Devens
Enterprise
Commission

Date: September 25, 2020

RE: Request for Determination of Slope Resource Area 111 Hospital Road

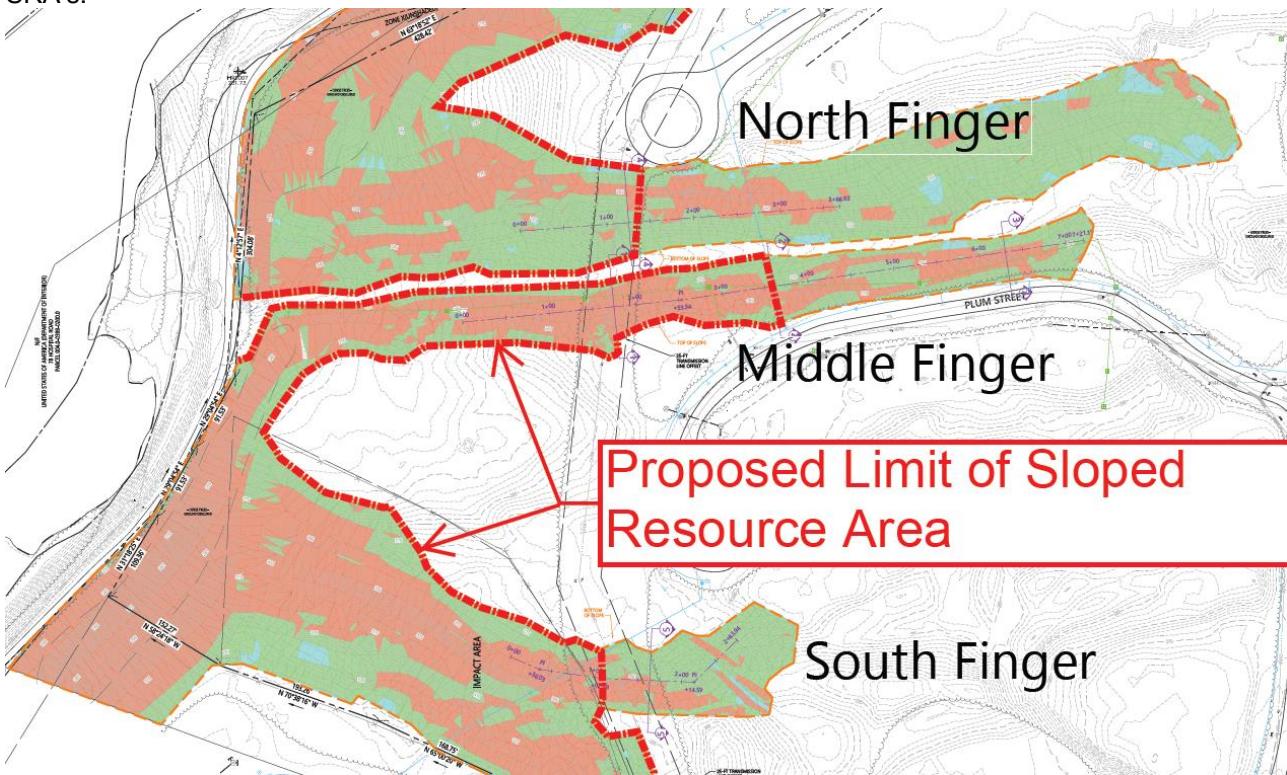
Staff has walked the site and reviewed CFS's slope analysis and supporting materials. Based on this information and the specific attributes of Steep Slopes as defined in the DEC Regulations, Staff would note the following with respect to the existing slopes on this parcel and whether or not they meet the definition of SRA:

1. **Naturally formed** – Yes – as evident from the geotechnical study and review of USGS topographical mapping dating back to 1929.
2. **Undisturbed** – Partially. Some SRA's like the middle finger area are dissected by utilities installed previously by the Army (water and drainage lines). MassDevelopment's 69kV above-ground powerline).

3. **Identified on the Devens Slope Resource Area Map** – Majority. CFS's more detailed analysis identified a small sliver of steep slopes that extend slightly out of the mapped area (the "South Finger").

4. **Slopes generally in excess of 35%** - Majority – some exceptions. CFS has analyzed the slopes based on ground surveys which are much more accurate than the mapping that the SRA map is based on.

5. **Contiguous areas of a ½ acre or more**. Majority – some exceptions. Some of the steeper areas are disconnected from the contiguous SRA's area that lead ultimately to the Nashua River and associated wetlands.

6. **Mature vegetative cover** – Yes – with the exception of the 69kv transmission line corridor dissecting the site.
7. **In close proximity to sensitive resource areas and/or unique geological formations** – while these slopes themselves can be considered unique geological formations, they do not appear to be in close proximity to any wetland or watercourse resource areas. They do ultimately drain into the Nashua River and associated wetland areas. This is a key issue since any instability/impacts to any steep slope areas within close proximity to wetland or watercourses could result in altered hydrology, erosion, and sedimentation that could significantly impact these resource areas. This

Overall, the green and red areas on CFS's Slope Analysis generally follow the SRA boundaries shown on the DEC's SRA map. The biggest discrepancy is the small south finger that area extends a little beyond what the DEC SRA map shows. Based on this information, CFS's proposed SRA boundary for this parcel is logical with a few minor tweaks (see below).

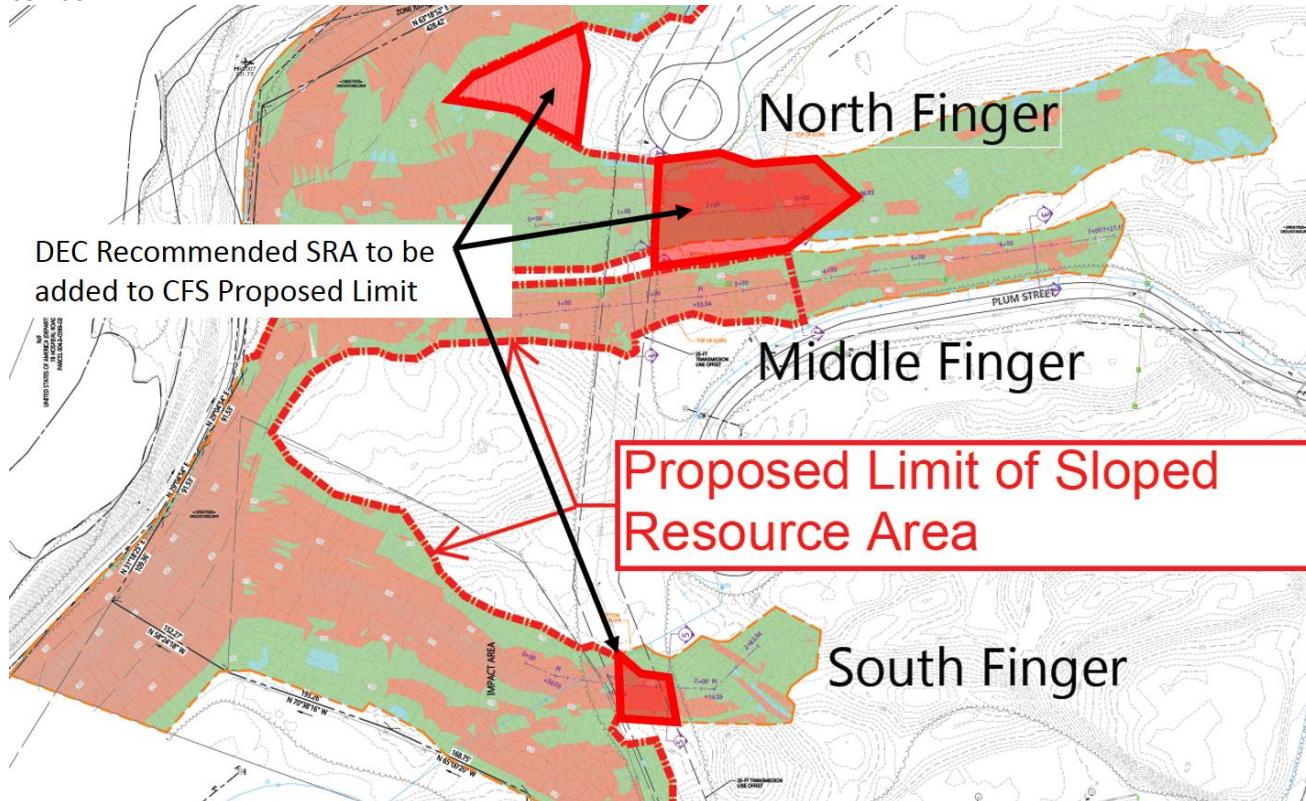
Recommendation: CFS is requesting that the DEC confirm the specific boundaries of the SRA's on-site as presented in the September 18, 2020 letter from VHB to help better inform their planning and design of their project. DEC Staff generally agrees with CFS specific delineation with a few recommended adjustments based on the existing grades and connectivity to other steep slope areas that link all the way to the Nashua River corridor:

If the DEC is in agreement, a motion could be made to agree with the Applicant's specific delineation of the Slope Resource Area as presented in the 9/18/20 letter and supporting documentation provided by VHB., Inc., and as modified by DEC Staff's 9-25-20 memo.
